5440 WADE PARK BLVD, SUITE 102 WWW.BGEINC.COM NC LICENSE #C-4397 ©2023	DESIGNED BY:				
	DRAWN BY:				
	REVIEWED BY:		DF		
			DF/JWM	10/02/2023	PER TOWN OF ROLESVILLE COMMENT
				08/01/2023	PER TOWN OF ROLESVILLE COMMENT
		REV	06/01/2023	INITIAL SUBMITTAL

PARKER RIDGE
82 SCHOOL STREET
ROLESVILLE / NORTH CAROLINA / 27571

CARVED STREET CT PLAN
AND PROFILE

C6-0

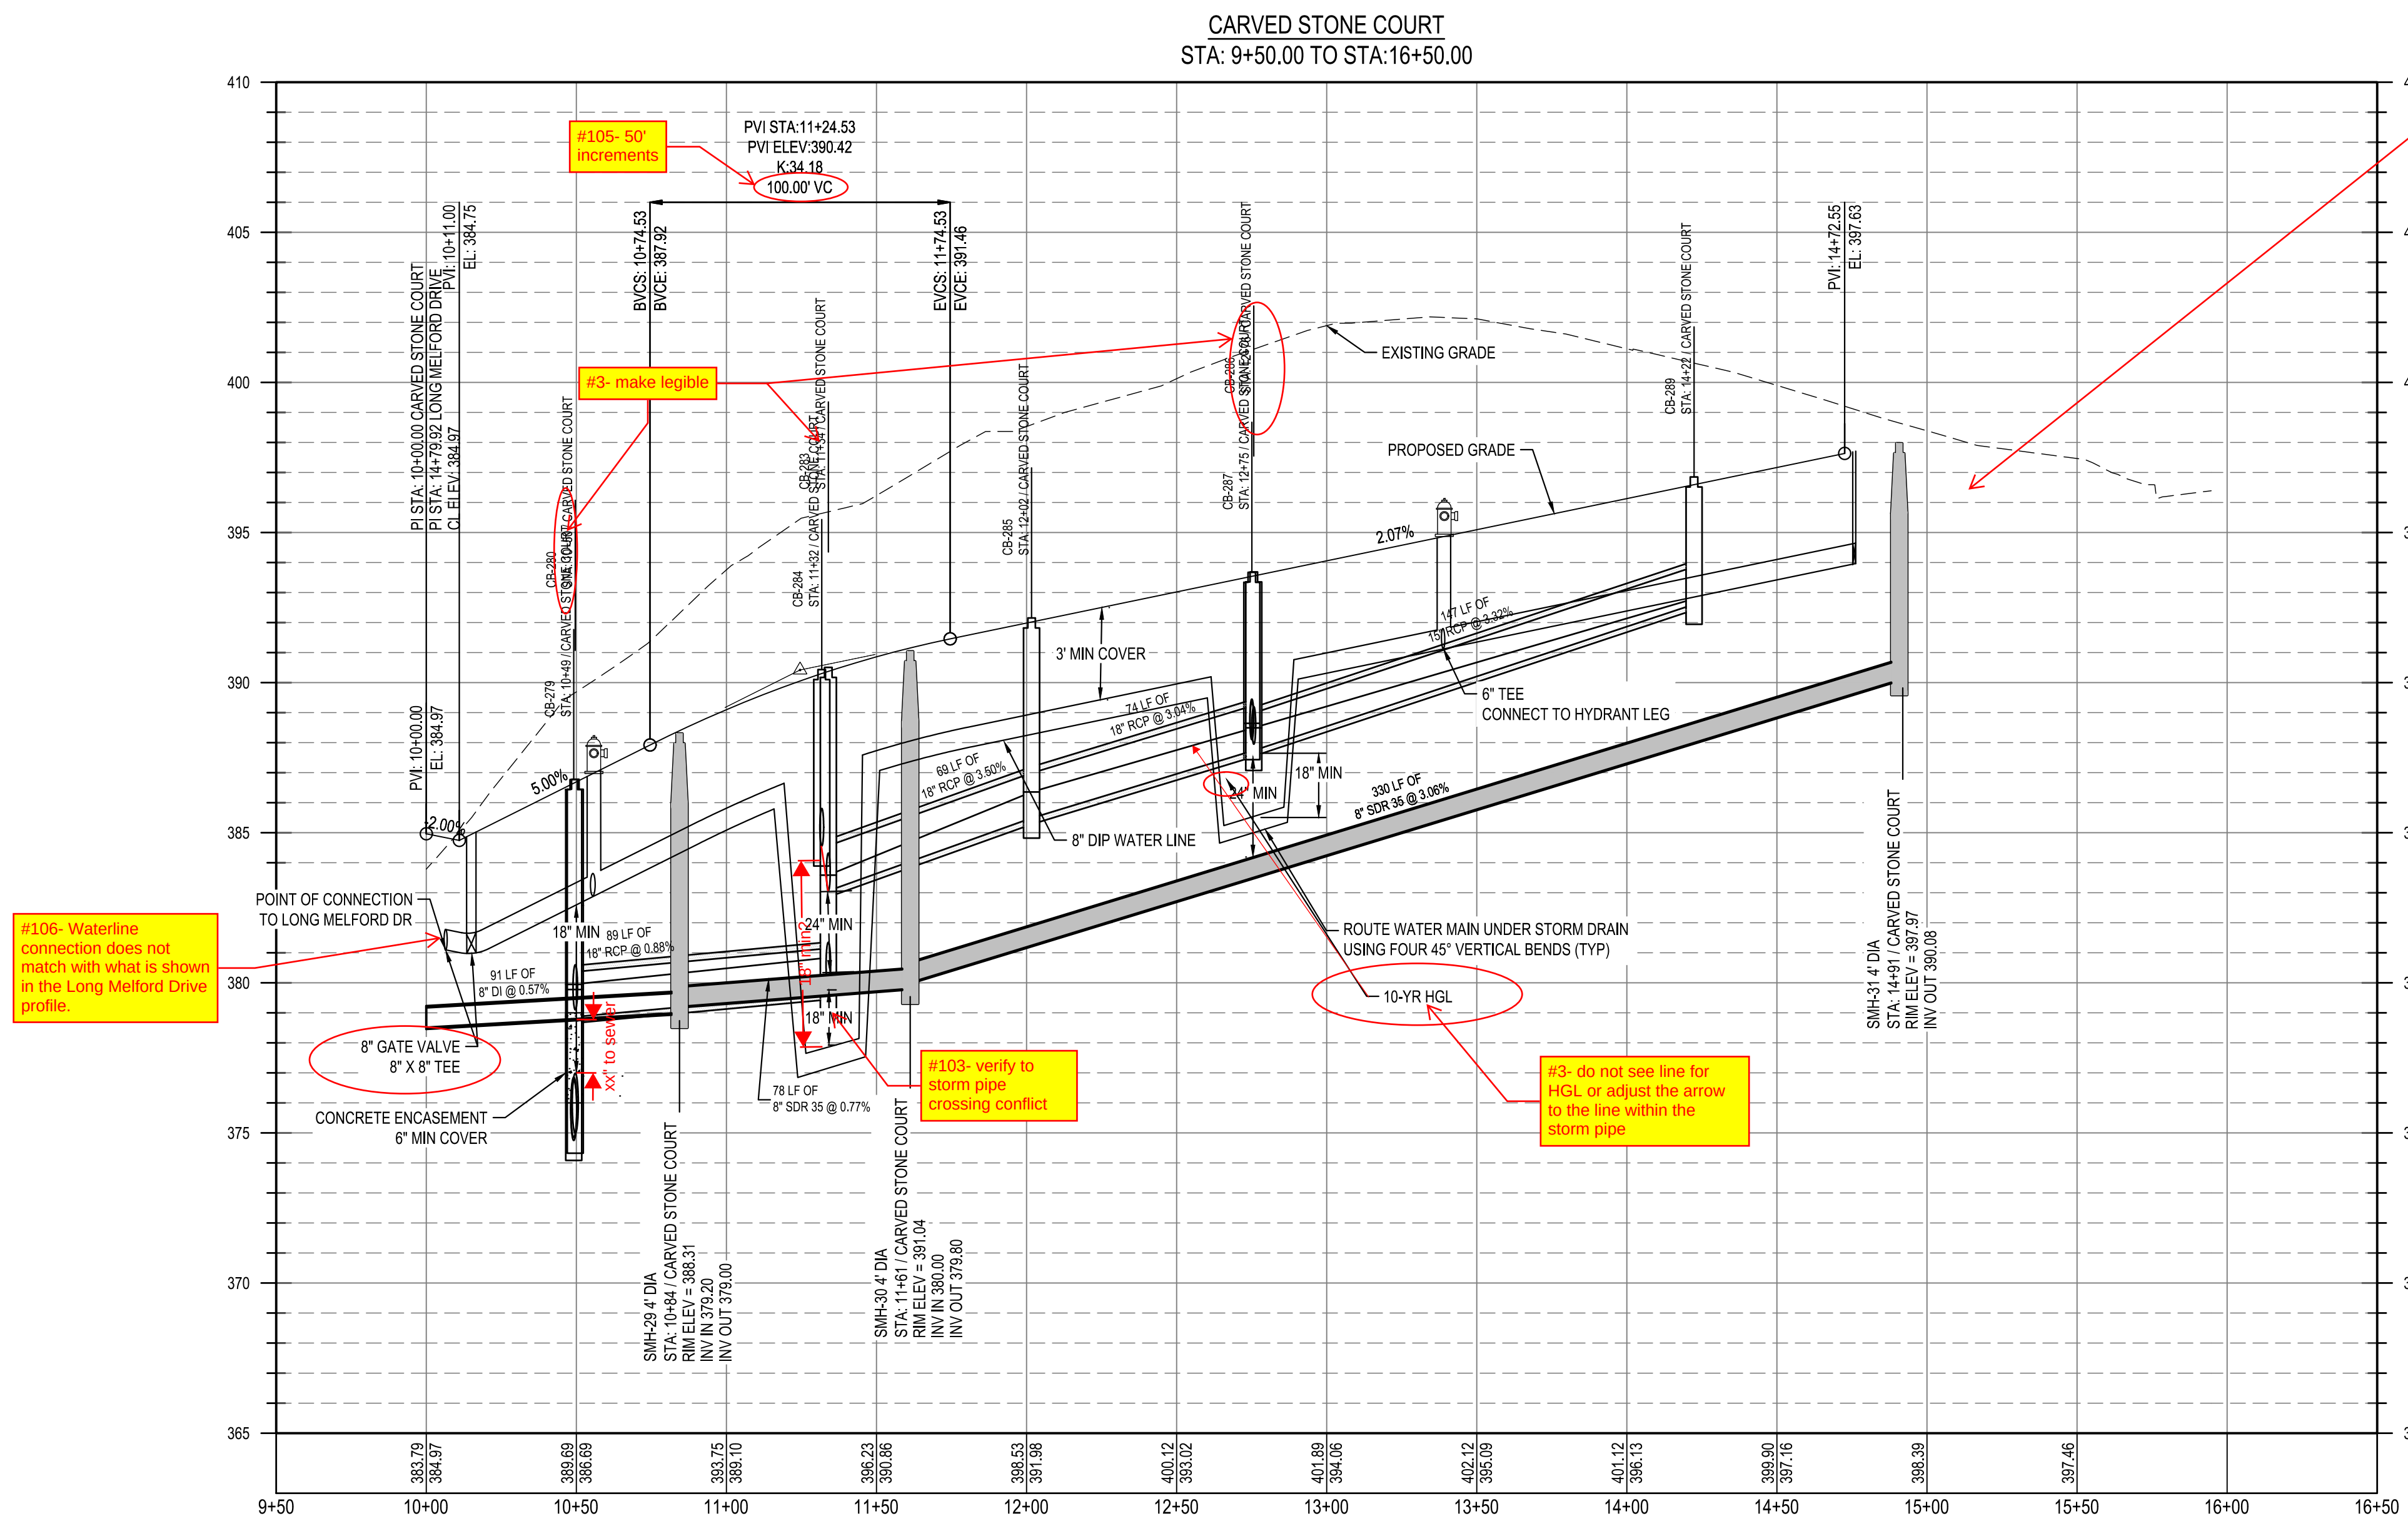
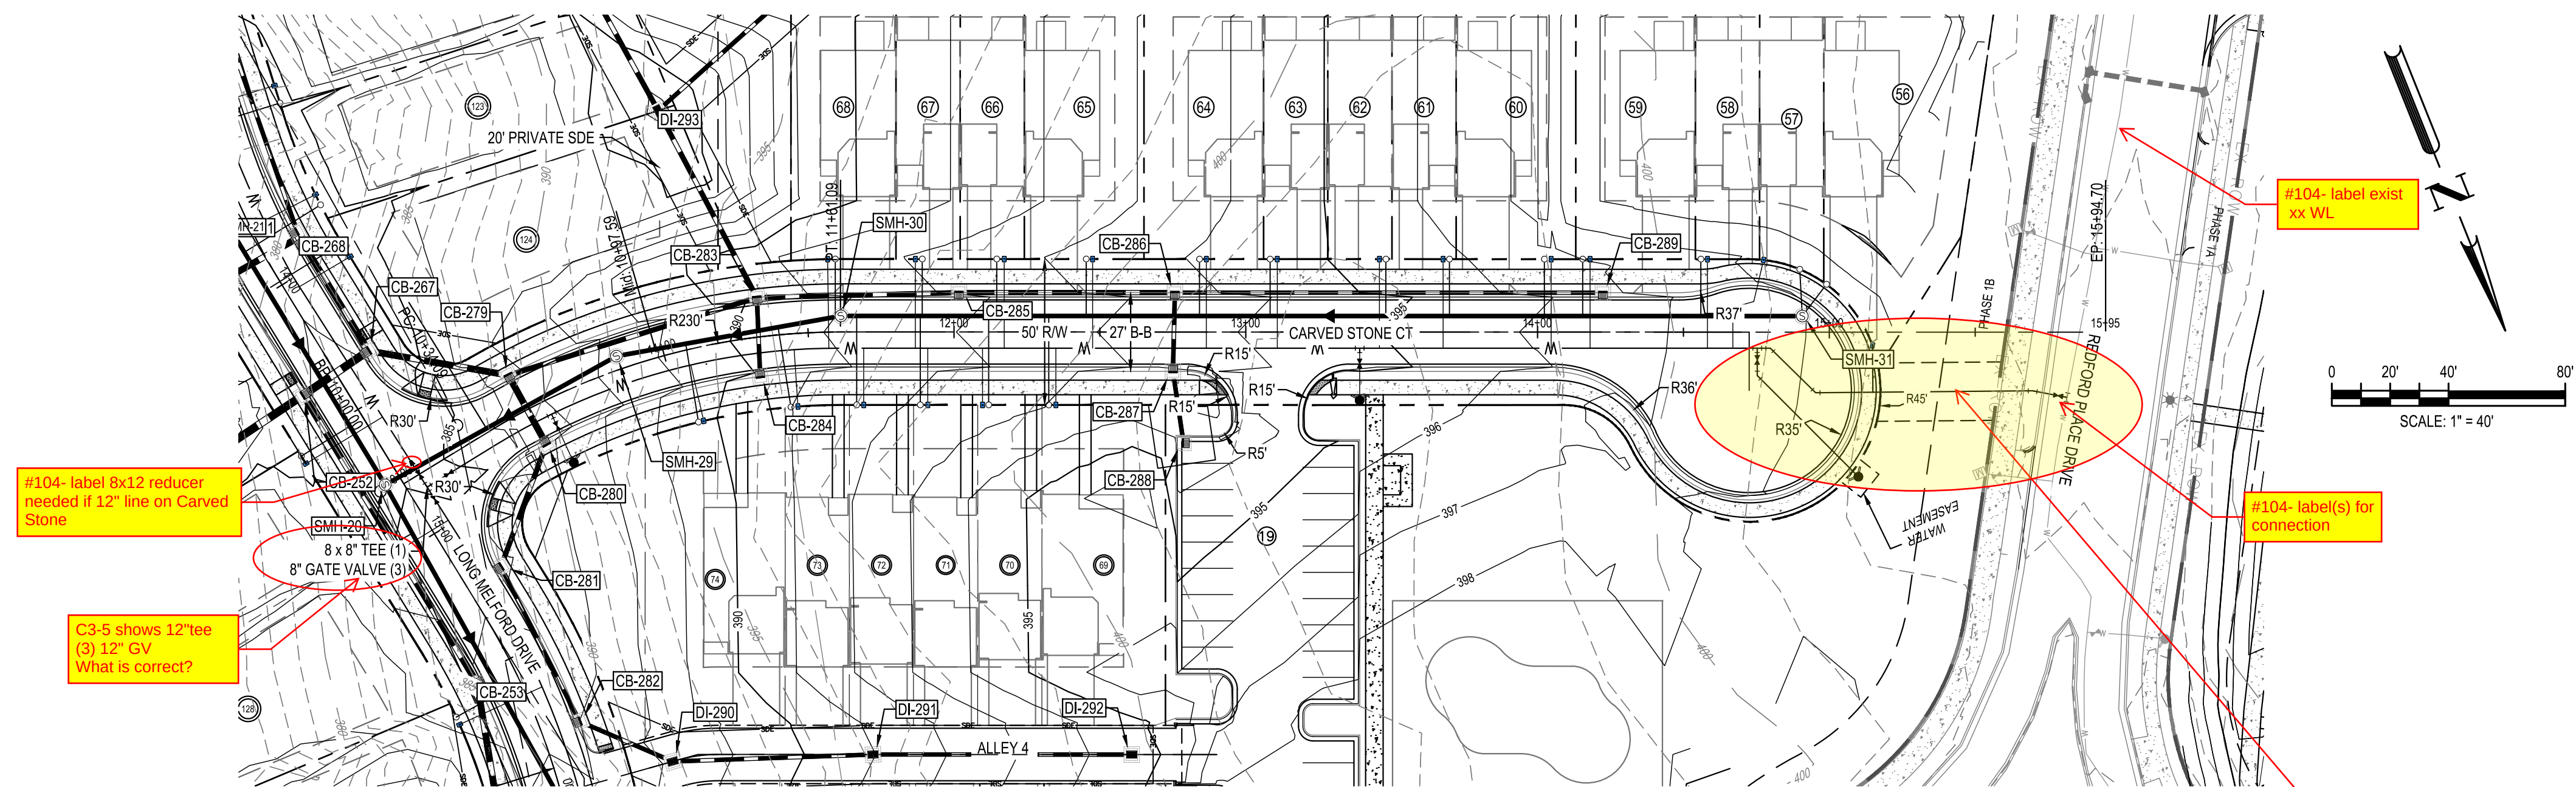
#102- Make sure dimensions are in the correct locations and it is clear what is being dimensions. Some dimensions don't seem to line up with top/bottom of pipes. If crossings do not meet minimum requirements, the design will need to be adjusted. Minimum separation requirements should be shown at all pipe crossings. This comment applies to all profile sheets.

#108- Carved Stone Ct.

#23- There are several instances where water line, tees/crosses, and valve sizes differ between Utility plan sheets and Plan and Profile sheets. Please make the necessary adjustments to ensure that water lines, connections, and valves correct sizes remain consistent throughout all sheets.
